THE LAND COURT OF QUEENSLAND

File Numbers: MRA082-13 & EPA083-13

Applicant: **HANCOCK COAL PTY LTD (ACN 130 249 973)**

JOINT EXPERTS REPORT ON GROUNDWATER

Figure: 1

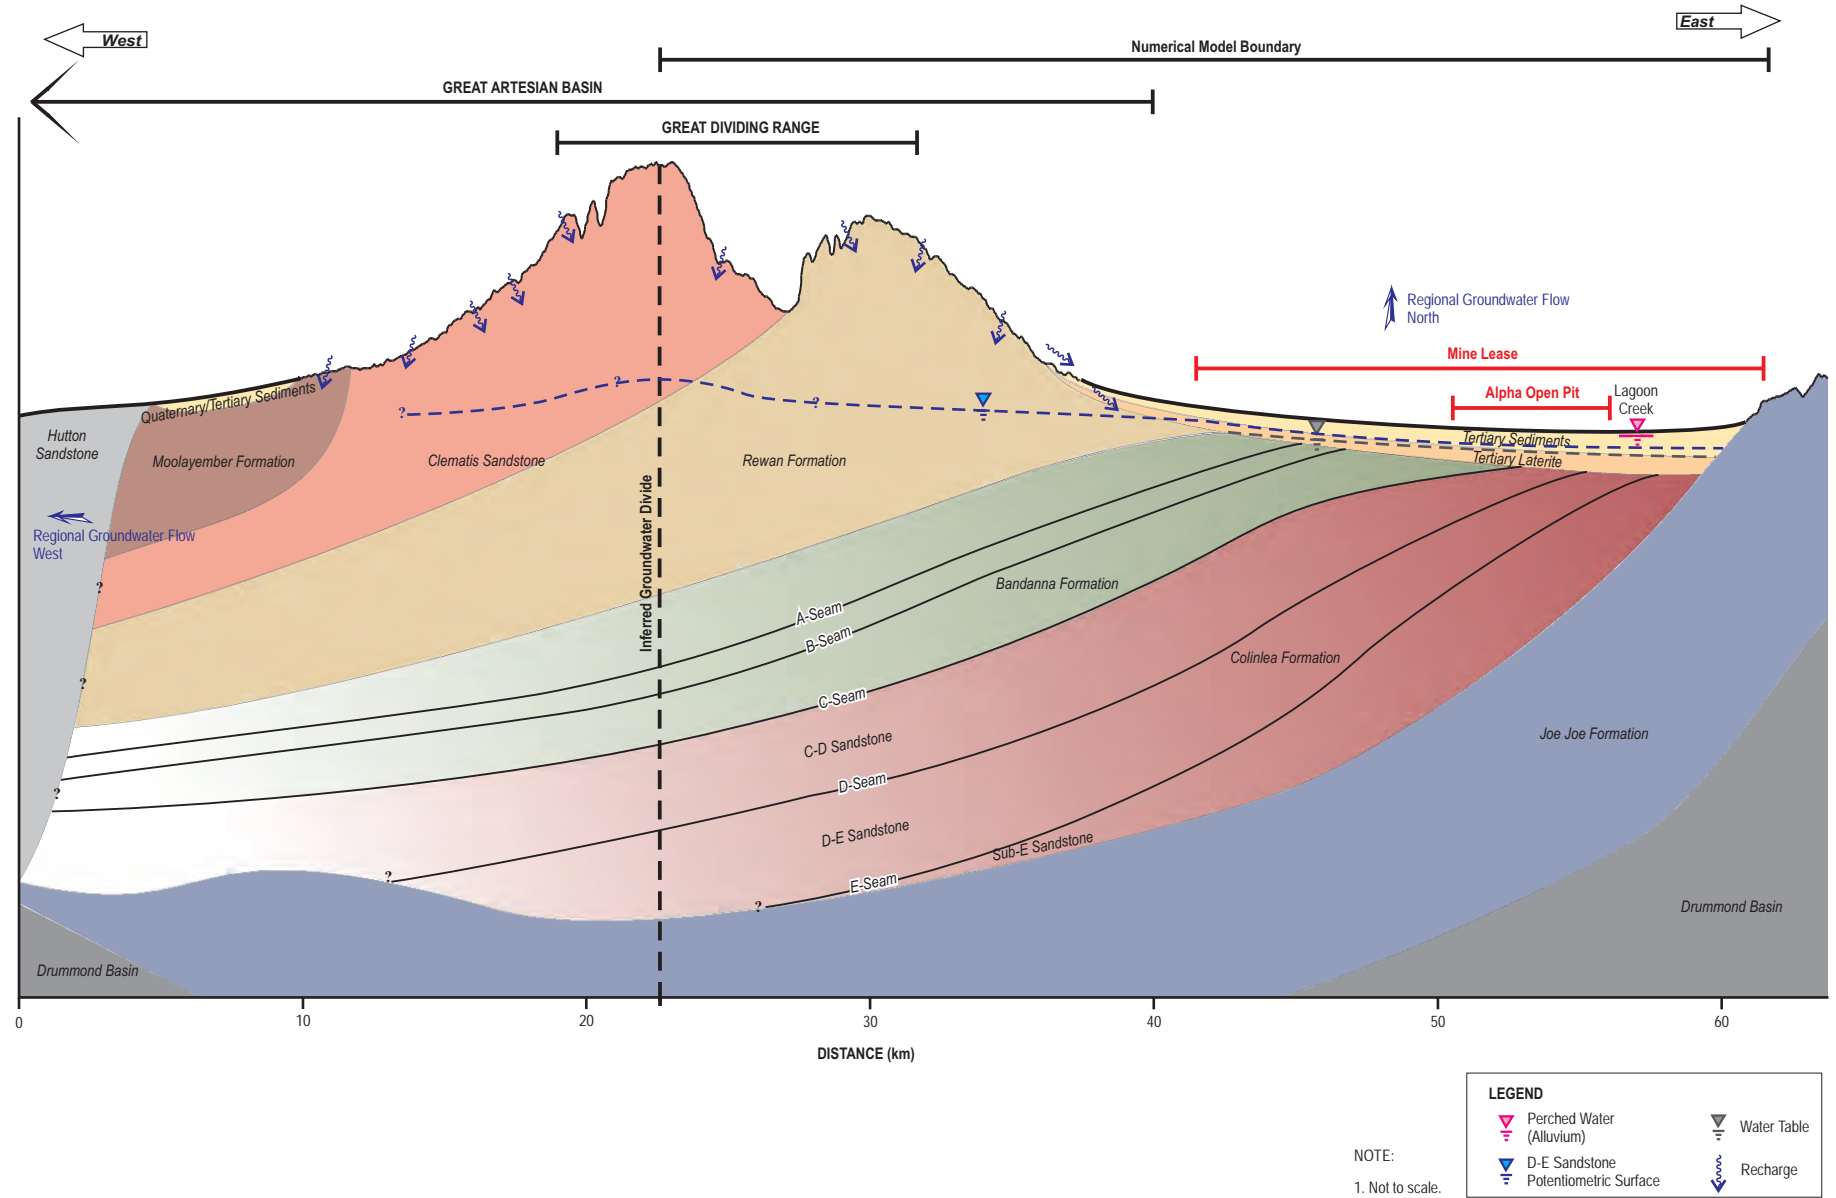
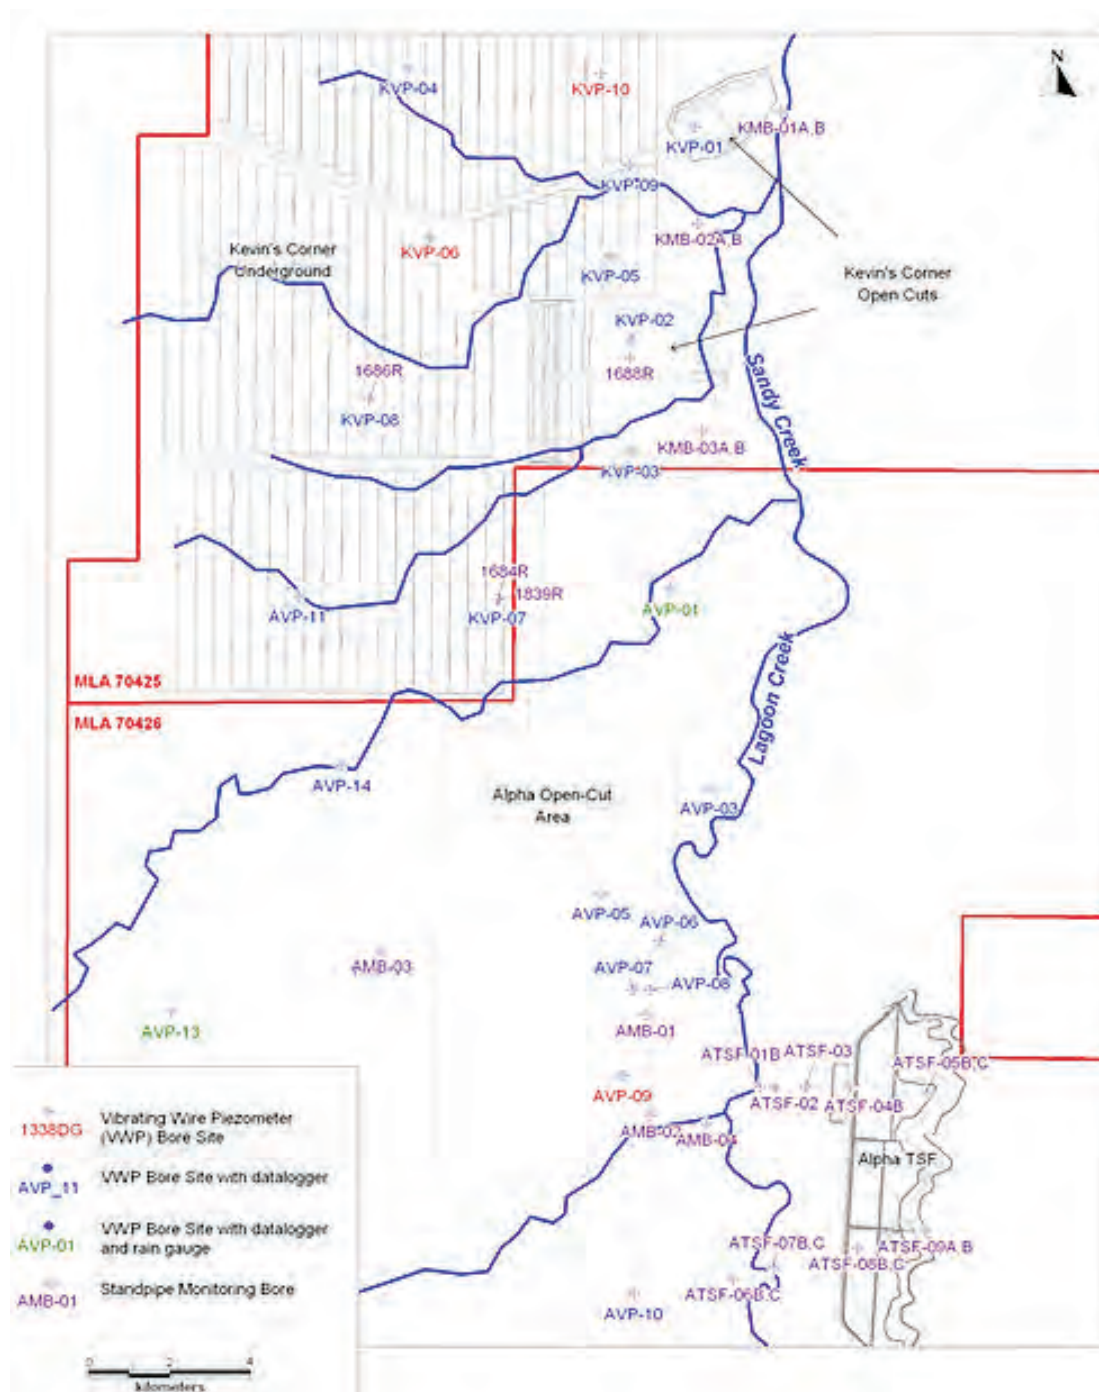
latest groundwater modelling report (URS, 2012). The latest Groundwater Conceptual Model is included in Appendix A Figure 1 attached.

93. Dr Webb does not agree that there is a no-flow boundary 10's of kilometers to the west where the Permian units pinch out against the Drummond basement. Firstly, none of the available cross-sections (apart from Appendix A, figure 1) show the Permian units pinching out against the Drummond basement. On the Salva cross-section, which Mr Stewart refers to several times, the Permian units pinch out against the overlying Triassic units, and this is also evident in other cross-sections, including the schematic cross-section in URS (2012).

99. The use of a no-flow boundary is considered conservative as it assumes no groundwater flow from the western side of the Great Dividing Range, even though the strata are hydraulically connected. The head and flux on the no-flow boundary, at the groundwater divide, are not constant and thus can change based on head (gradient) and hydraulic conductivity (k) changes dependent on the adjacent model cell. In reality there may be additional flux into the system based on the hydraulic connection. The no-flow boundary in reality is some 10s of kilometres to the west of the model boundary where the Permian units pinch-out against the Drummond basement (Appendix A Figure 1).

Figure: **4**

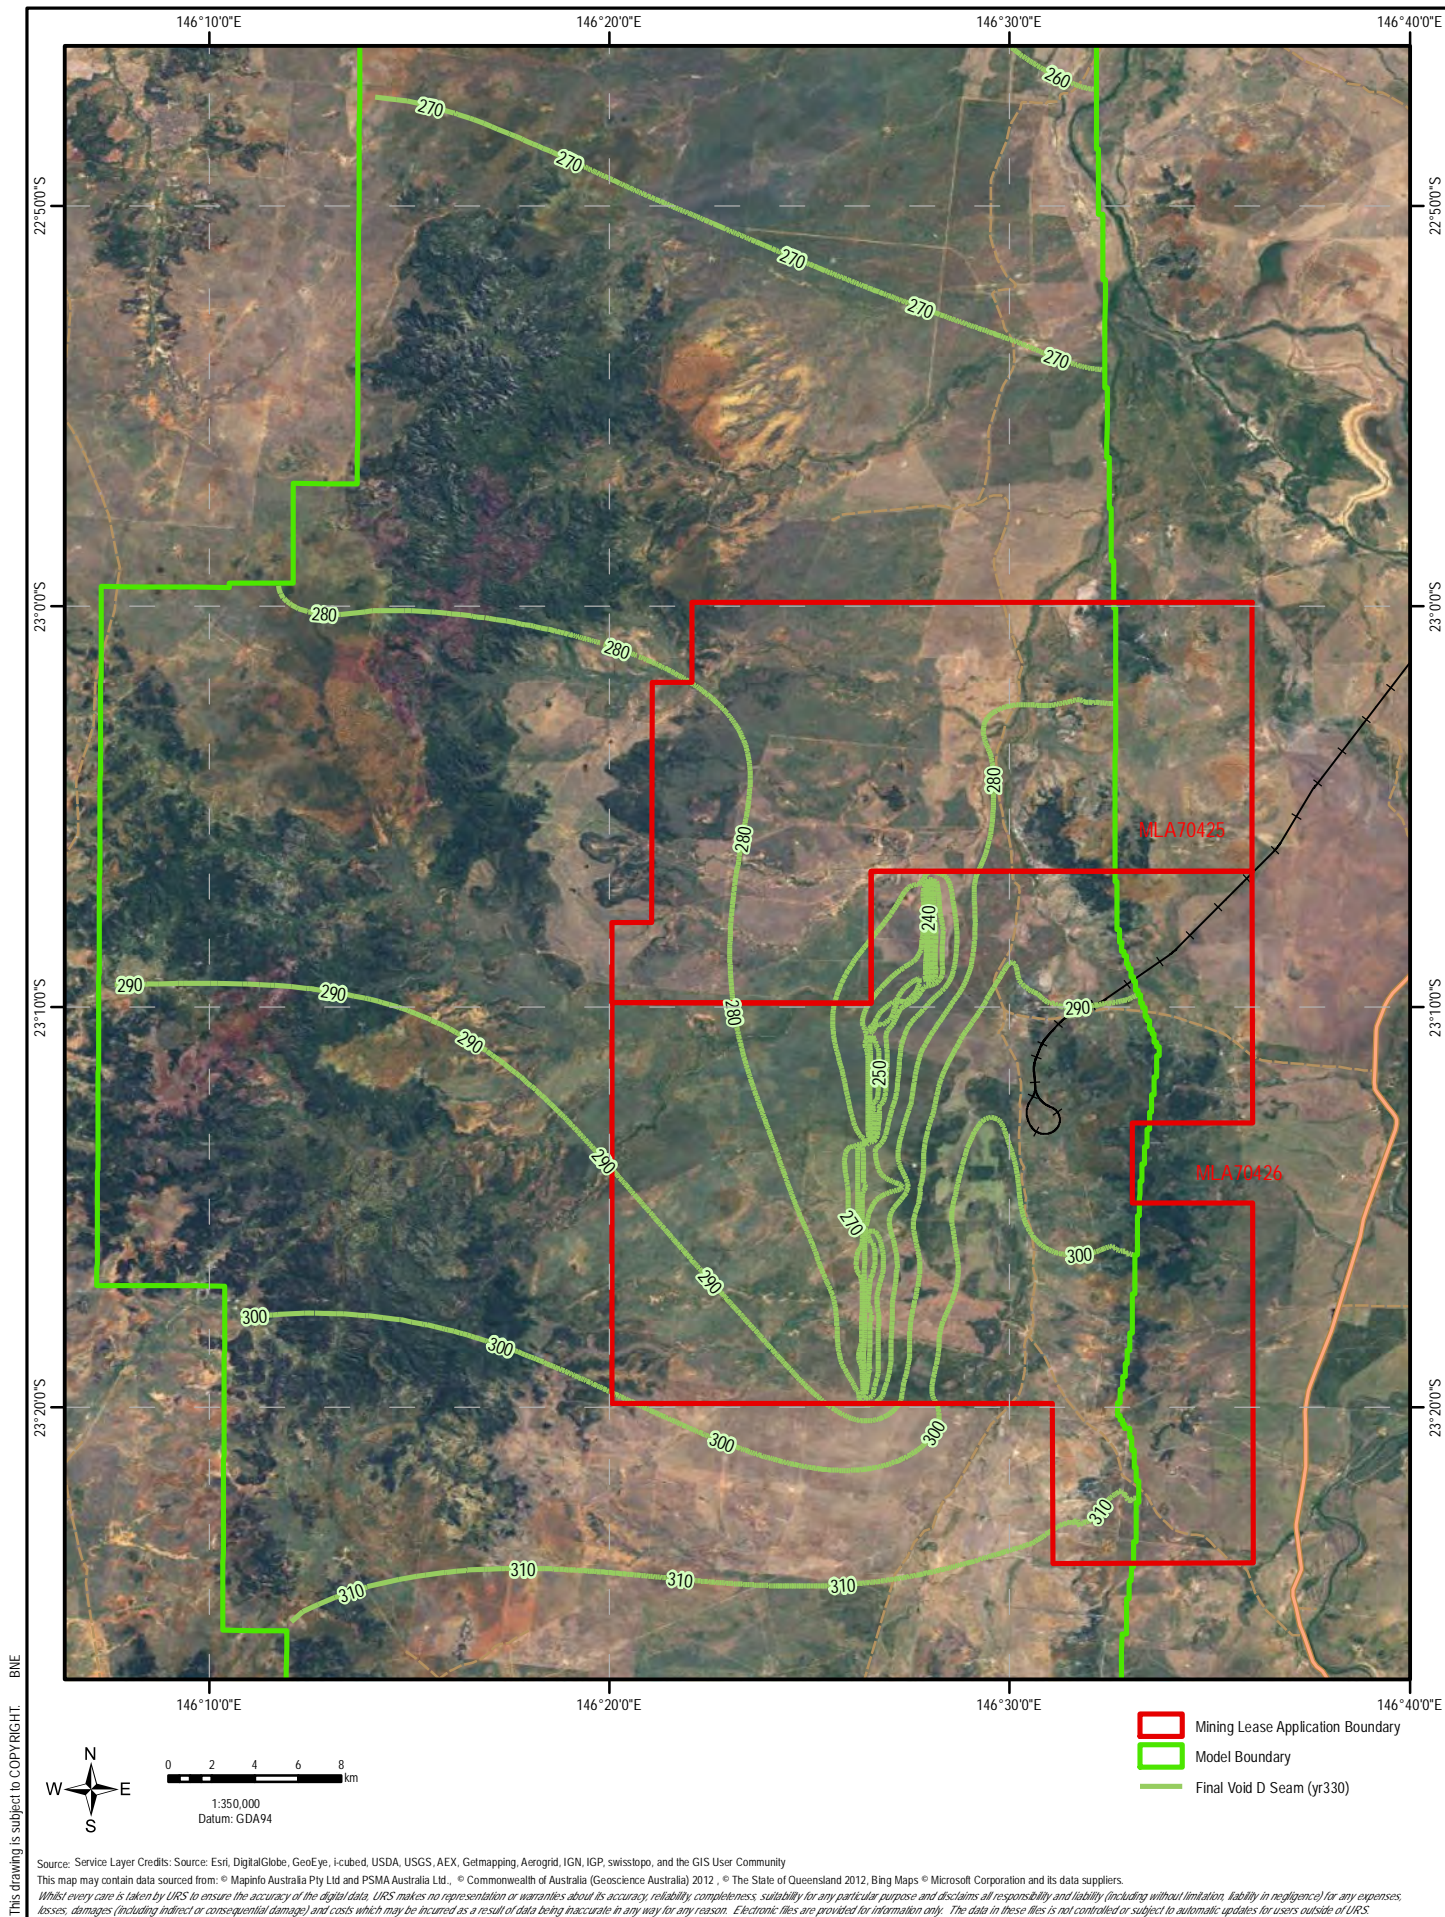
98. Mr Stewart considered the use of a no-flow boundary within the Great Dividing Range (as shown in Appendix A Figure 4) which allowed for a conservative approach in order to assess potential impacts to the west of Alpha Coal Mine. It was recognised that a groundwater divide is likely to exist within the Great Dividing Range based on available groundwater level data from the Department of Natural Resources and Mines (NRM) groundwater database. The database includes one observed groundwater level to the west of the Great Dividing Range being lower than an observed groundwater level east of the range (Section 7.4.1 Groundwater Model Report, URS 2012). As groundwater flow is recognised to flow northeast on the eastern side of the divide it was interpreted that a likely groundwater divide exists. Thus a no-flow boundary was assumed in the model to represent the groundwater divide.

Figure: **5a**

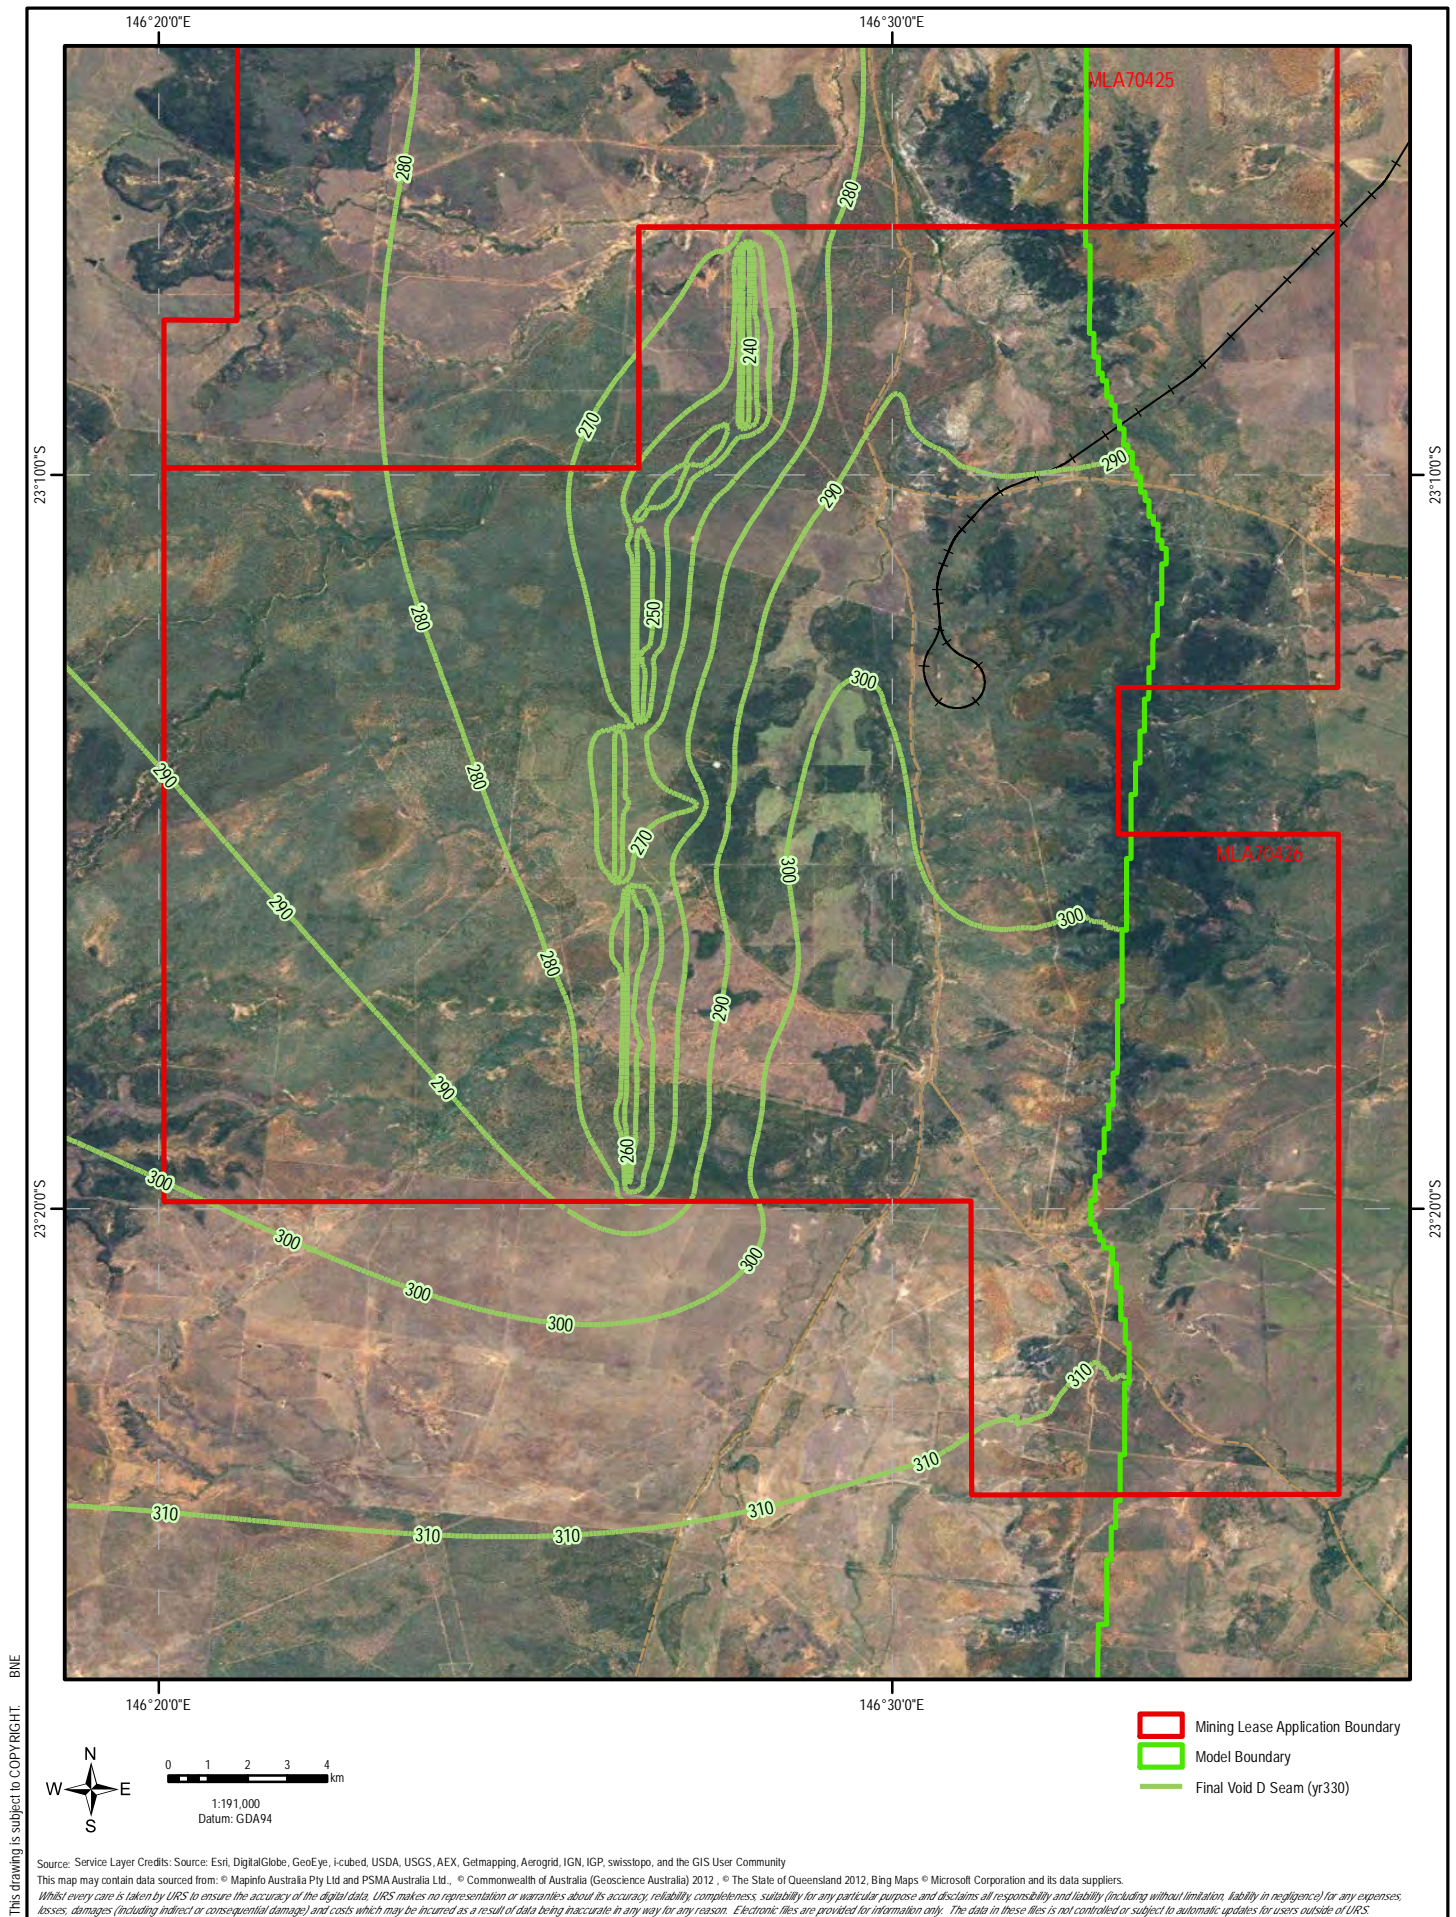
of Alpha Coal Mine based on aquifer hydraulic parameters (hydraulic conductivity and storage) and the predicted drawdown (0.5 m drawdown in the D coal seam) only extends to the western mine lease boundary at the end of mine life (Appendix A Figure 5a). The predictive modelling indicates that groundwater drawdown at the end of mining and post-closure (300 years) does not result in drawdown at the groundwater divide. The predicted drawdown contours in the D seam after 300 years, associated with the final void, is presented in Appendix A Figure 5b.

boundary. It is, however, noted that the drawdown does not extend sufficiently westwards from the Alpha Coal Mine to result in drawdown at the model no-flow boundary (Appendix A Figure 5a).

Figure: **6a**

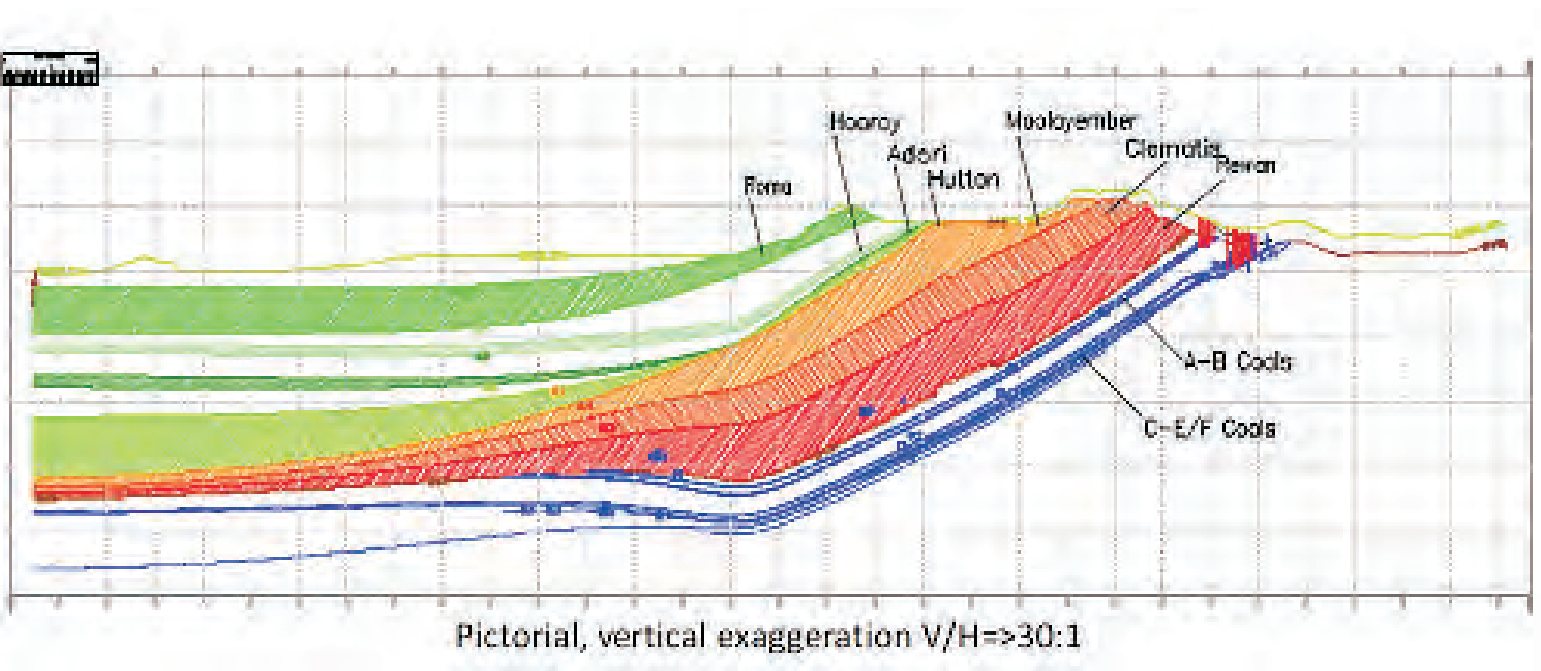
75. The Salva Resources GAB Report (memorandum dated 18 February 2009) provided a plan view of formation subcrops (Appendix A Figure 6a) and a west-east cross-section across the GAB and Galilee Basin (Appendix A Figure 6b). According to the Salva Resources memorandum the regional geological model had been compiled based on:

76. During the Joint Experts Meeting it was discussed that the subcrops matched the outcrops mapped on the Jericho 1: 250 000 geological map as well as the coal seam subcrops. Dr Webb provided data for comparison which showed the Rewan Formation subcrop contours did not match; however, he was not able to provide the source of the data. It was discussed that the Rewan subcrop mapped by Salva Resources was the upper (western) edge of the formation, which may explain the difference if Dr Webb's data considered the eastern edge.
